ISSUE: Certificate of Appropriateness for new construction

APPLICANT: City of Alexandria and Washington Metropolitan Area Transit Authority (WMATA)

LOCATION: Old and Historic Alexandria District
2500 Potomac Greens Drive (2405, 2501, 3701 Potomac Avenue, 3251 Potomac Avenue [Parcel ID 016.04-01-01], 700 Carpenter Road, 1702 and 1880 Potomac Greens Drive) 2901 Potomac Avenue (2405, 2501, 3701 Potomac Avenue, 3251 Potomac Avenue [Parcel ID 016.04-01-01], 700 Carpenter Road, 1702 and 1880 Potomac Greens Drive)

**Contract No. FQ16146 - Washington Metropolitan Area Transit Authority
(WMATA) Potomac Yards Metrorail Station
LTR-0118-PM-City of Alexandria February 19, 2020 BAR Submission**

RENDERING OF ENTRANCE – MAIN APPROACH

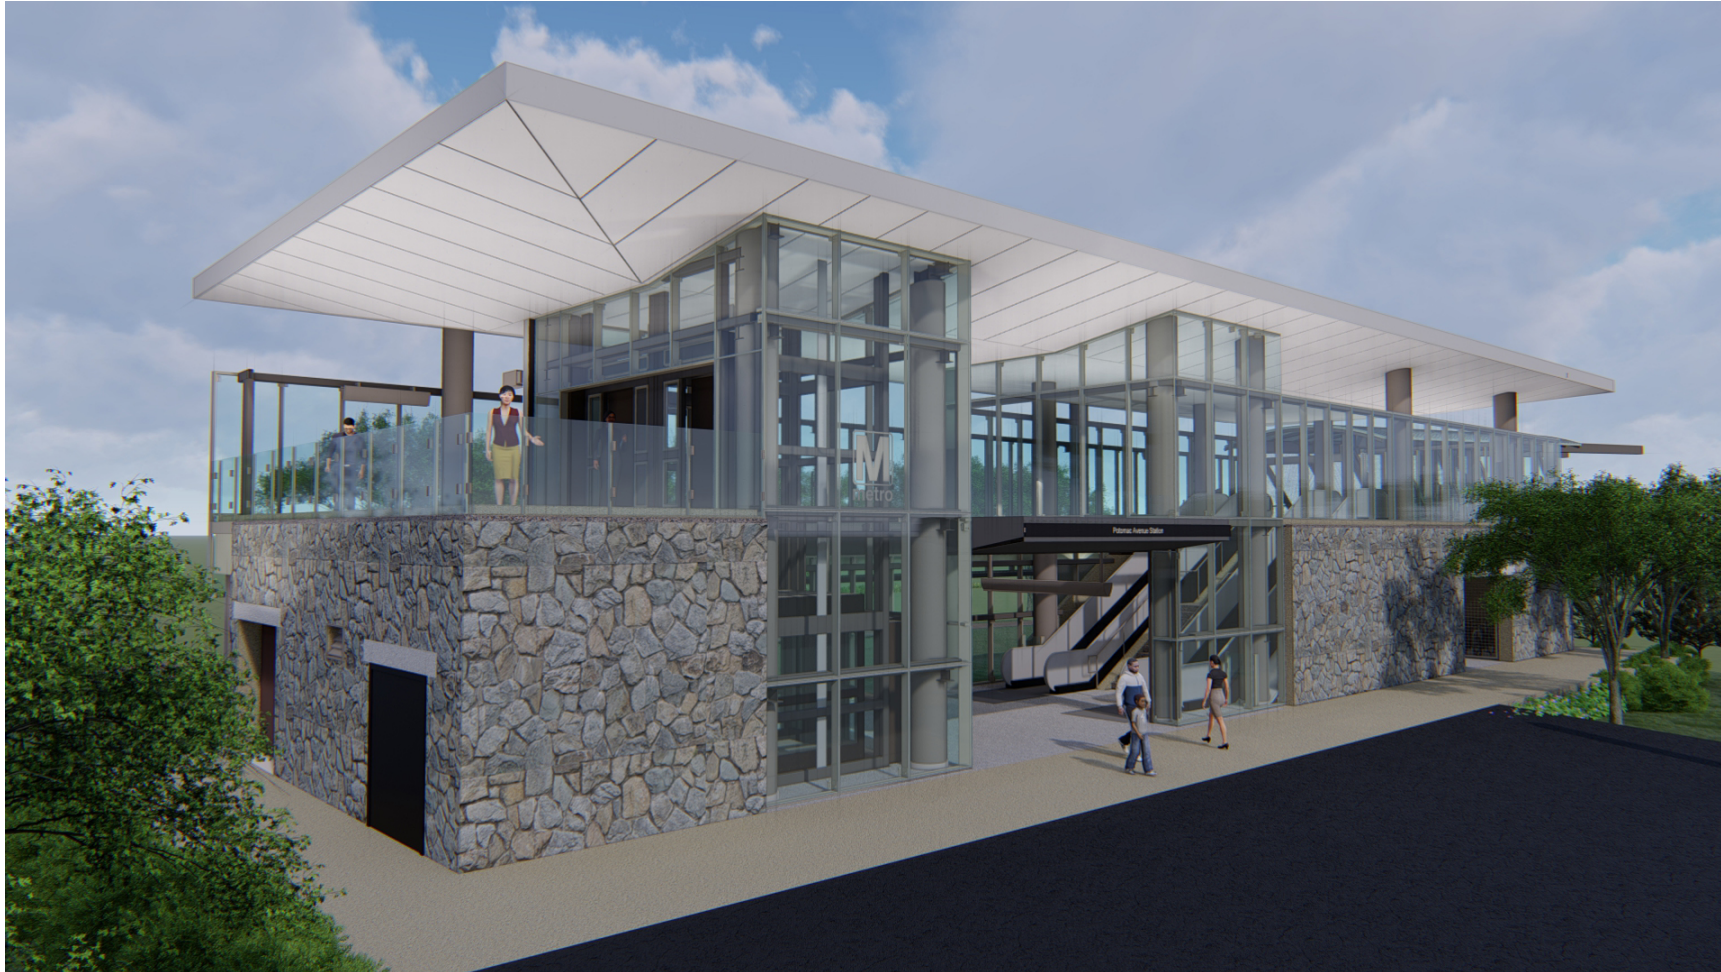
At a previous presentation, the BAR the members expressed concern for the sloping stone wall on the west elevation of the entrance pavilion that followed the angle of the escalator, saying that this angle seemed arbitrary and out of context with the other forms in the project, and were confused about the materials and lighting of the roof/ceiling. The BAR suggested a rectangular form with a more symmetrical and monumental entry. The Board also agreed with staff that architectural

details for the coping and lintels above the doorway needed to be shown. The applicant has responded with new renderings that comply with all of the BAR's previous comments and staff supports the revised design.

- ADDED STONE LINTELS OVER THE DOORS
- CREATED A SYMMETRICAL ENTRANCE
- UPDATED TO REFLECTED GLAZING SYSTEM ELEMENTS

FEBRUARY 2020 | SHEET 9

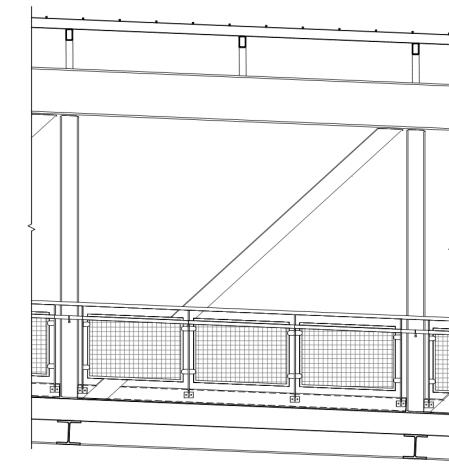
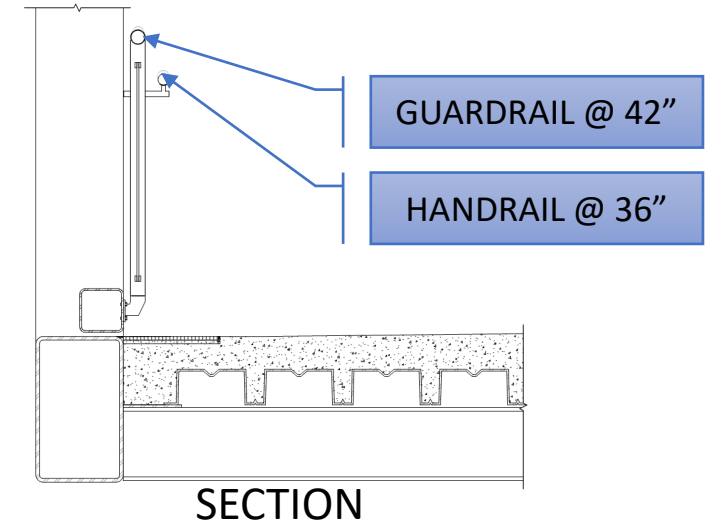
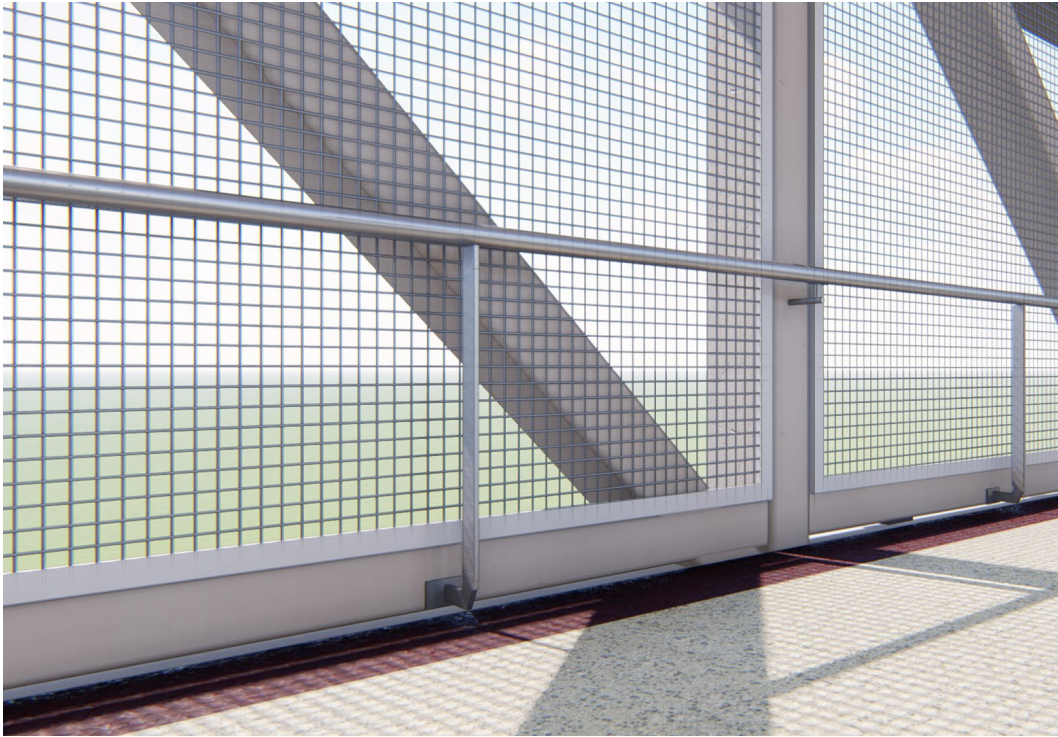
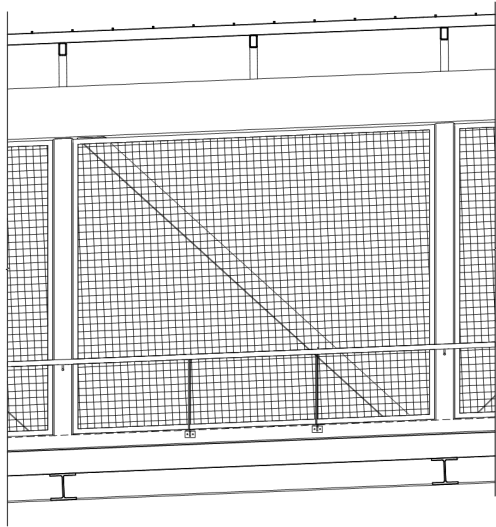
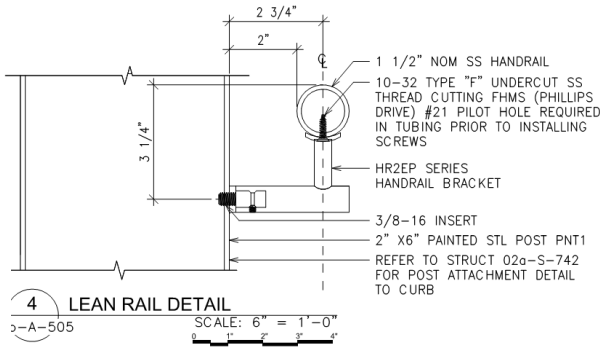
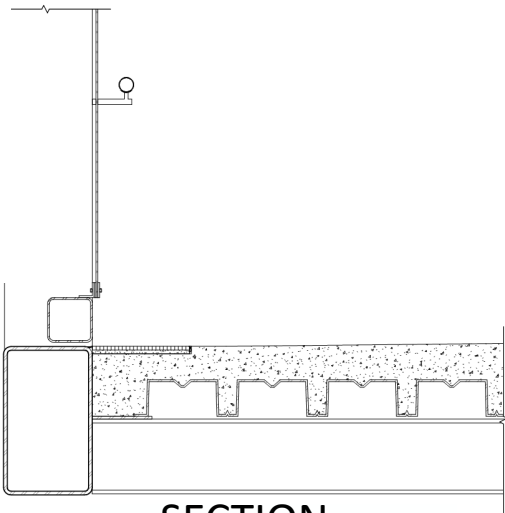
The previous presentations showed several different guardrail designs. The renderings in the application are now updated and sheets 9, 10 & 11 show wire mesh and glass guardrail construction details for the pedestrian bridge and station platform. As requested by the BAR, the designs have been simplified and relate to the mesh walls on the bridge or the curtain wall detailing of the mezzanine. Staff supports the proposed refinements.

7.d.	Restudy the proportions, connections and construction details of the following: Glass handrail details at the station platform;	Open	Bracket concept was not rejected but BAR chose to differ approval pending a detail being reviewed	July 14, 2019 Staff Report	2/19/2020

LOUVER CONNECTION – HEAD HOUSE

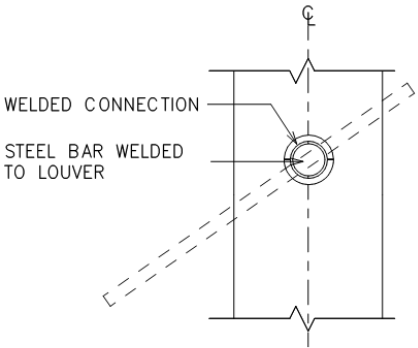
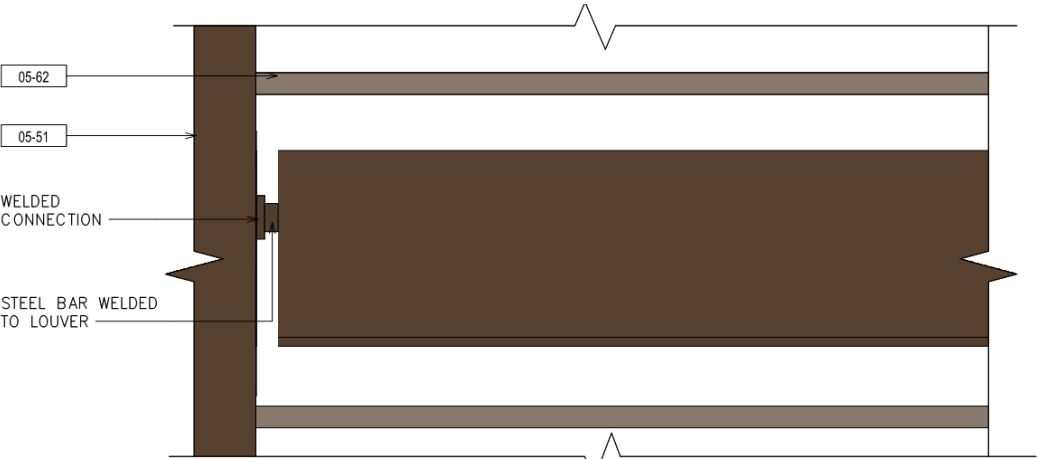
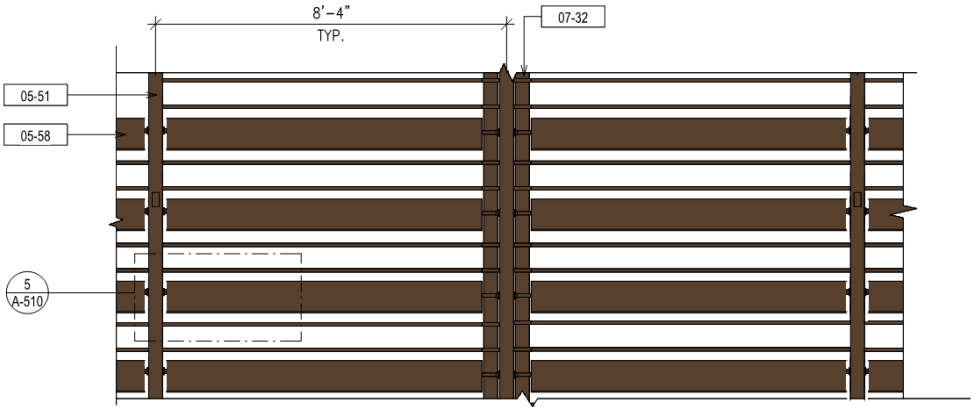
Early presentation drawings did not explain how the louvers in the exoskeleton at the mezzanine were connected to the larger structural framing and their relationship to the curtain wall glazing. Application drawing sheets 12 and 13 now describe the size of the steel louvers and shows the angle and spacing. These details are consistent with the updated renderings and staff supports the details, as shown.

7.e.	Restudy the proportions, connections and construction details of the following: Metal louver connection details;	Open	Connection concept was not rejected but BAR chose to differ approval to finalization of the exoskeleton finish	July 14, 2019 Staff Report	2/19/2020
